MIL-F-24402D(SH)
AMENDMENT 1
24 October 1983

MILITARY SPECIFICATION

FILTERS (HYDRAULIC), FILTER ELEMENTS (HIGH EFFICIENCY),
AND FILTER DIFFERENTIAL PRESSURE INDICATORS

This amendment forms a part of Military Specification MIL-F-24402D(SH), dated 12 April 1982, and is approved for use by the Naval Sea Systems Command, Department of the Navy and is available for use by all Departments and Agencies of the Department of Defense.

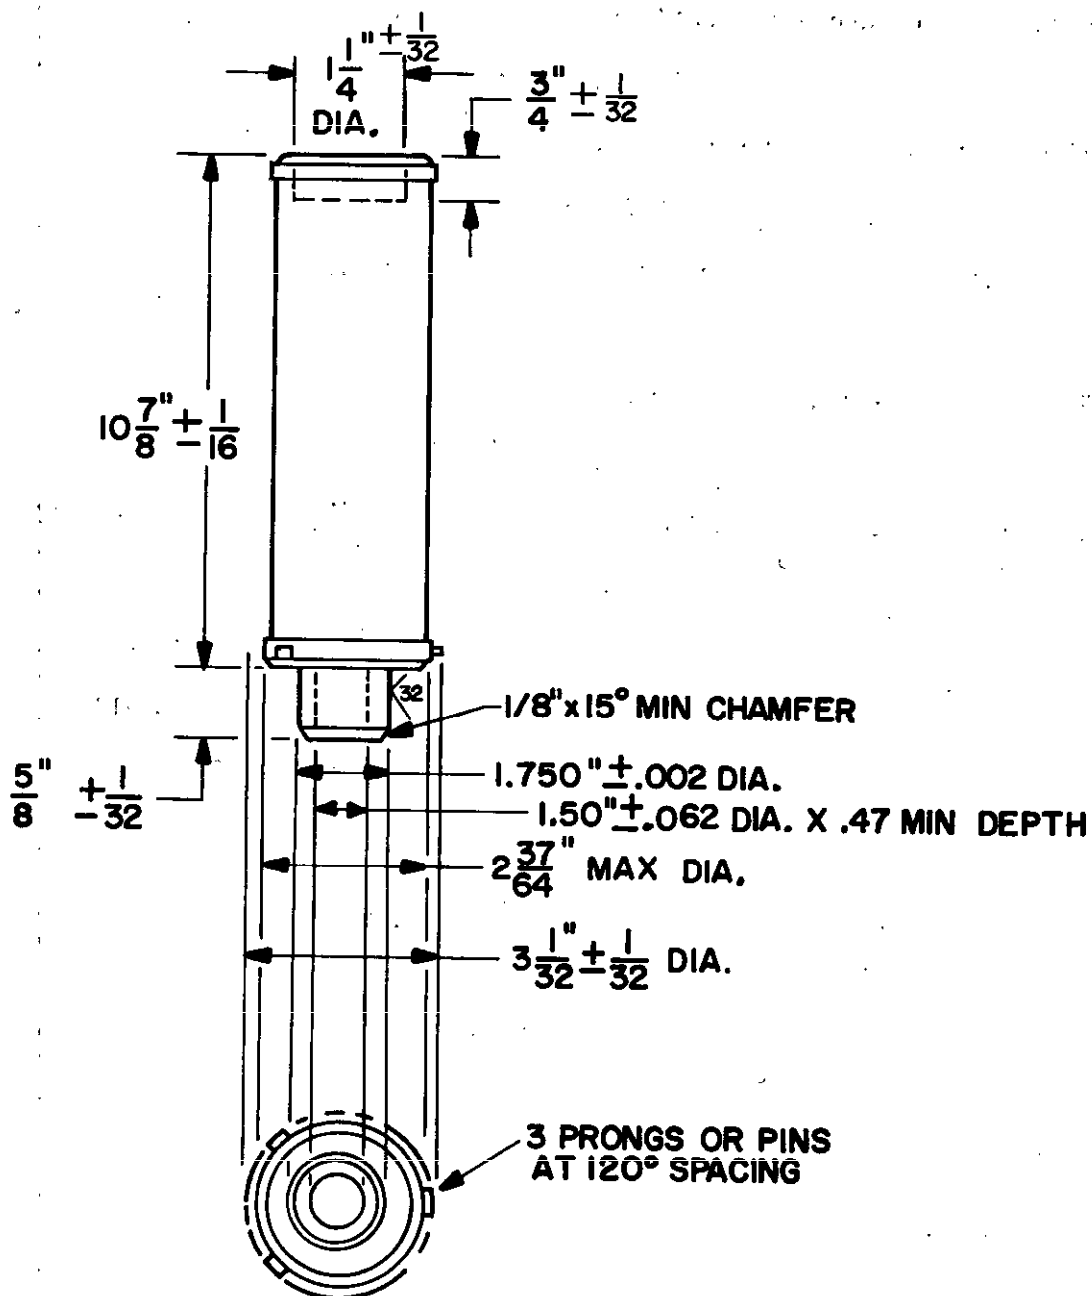
Figure 11: Delete and substitute the attached figure 11.

FIGURE 9. Type 2N and 2R, class BF filter manifold assembly
outline dimensions. - Continued

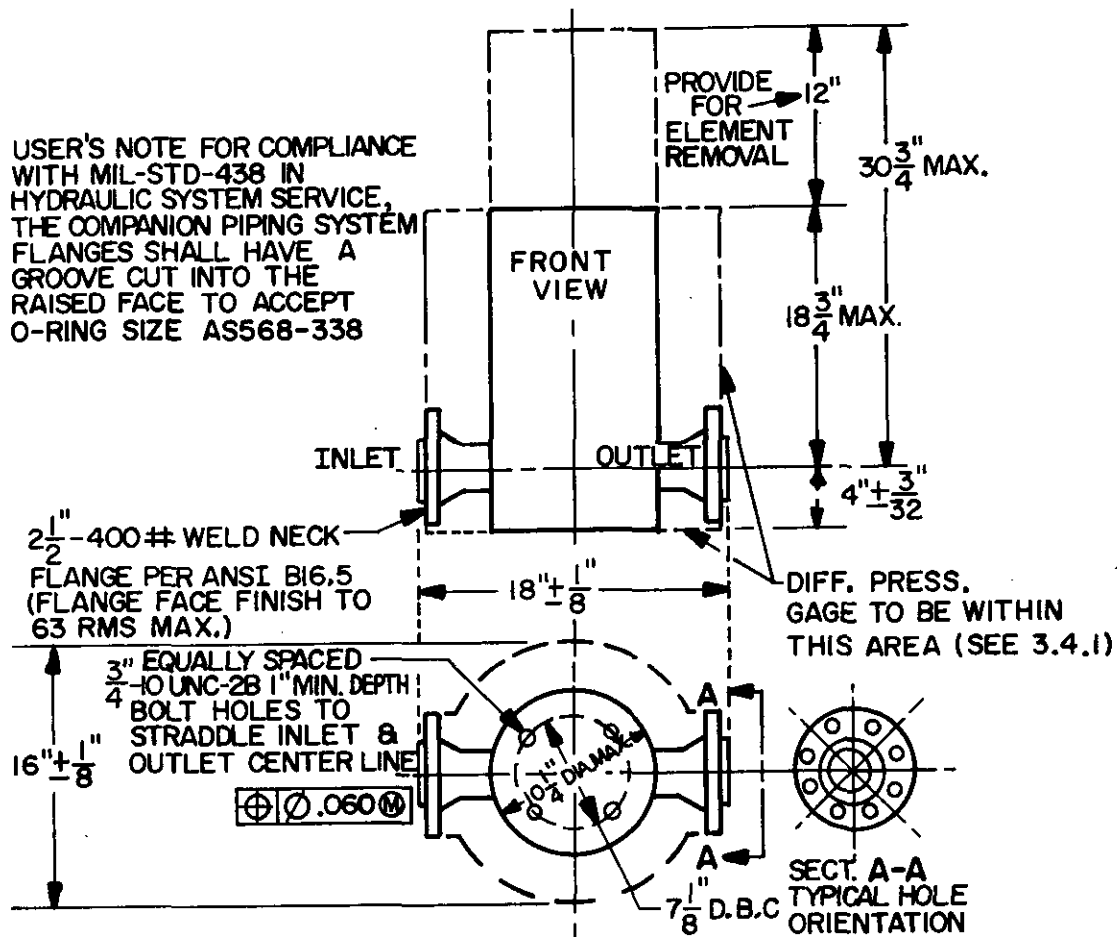
Figure 9: Delete and substitute the attached figure 9.

- (1) PIECES 1, 2, AND 3 PROVIDED BY USER.
- (2) FOR ASSEMBLY, PIECE 2 OUTSIDE DIAMETER PRESSES INTO MATING FLANGE DETAIL. ON FILTER ASSEMBLY DIMENSION $1.563^{+0.002}_{-0.000}$.
- (3) O-RING FITS GROOVE CREATED BY SLEEVE Q.D. AND MATING FLANGE DETAIL DIMENSIONS $2.125^{+0.002}_{-0.000}$.

FIGURE 1. Filter elements dimensions, size A.

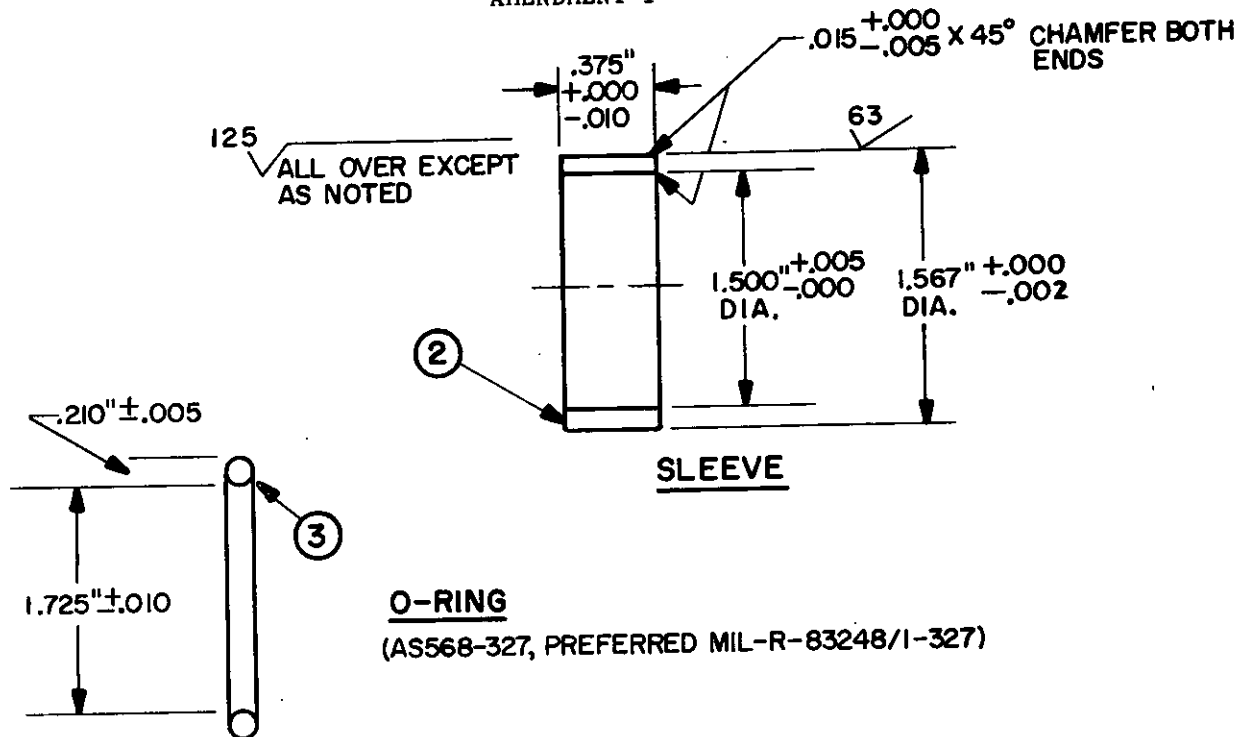
Figure 1: Delete and substitute the attached figure 1.

FIGURE 7. Type 3N and 3R, class BF filter assembly outline dimensions.

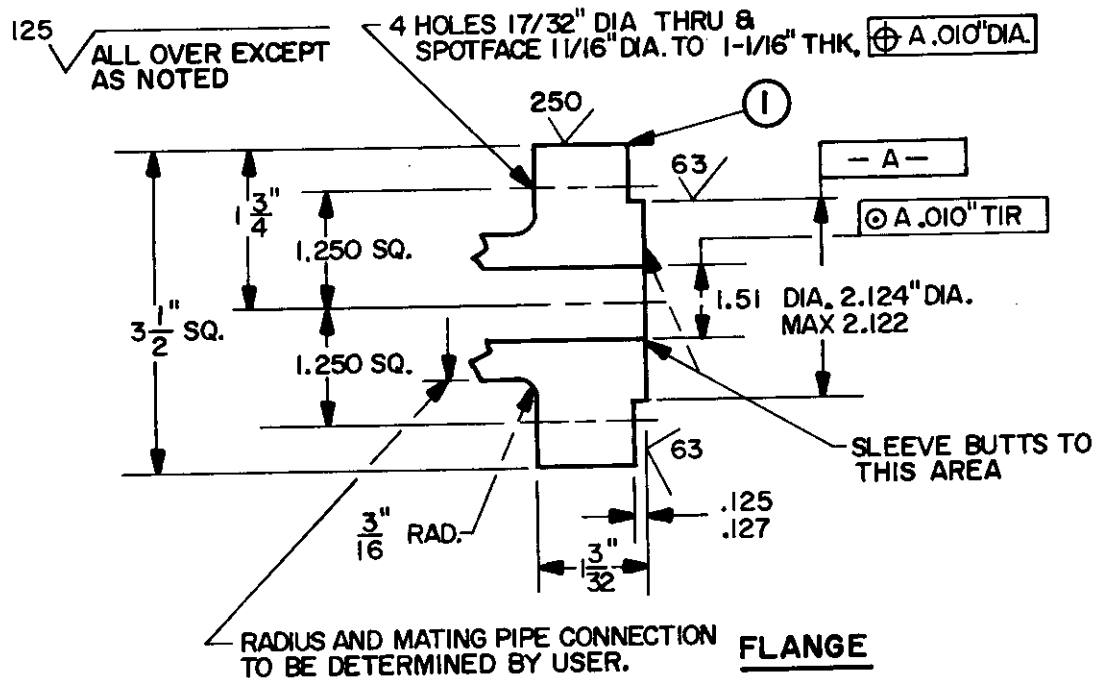
Figure 7: Delete and substitute the attached figure 7.
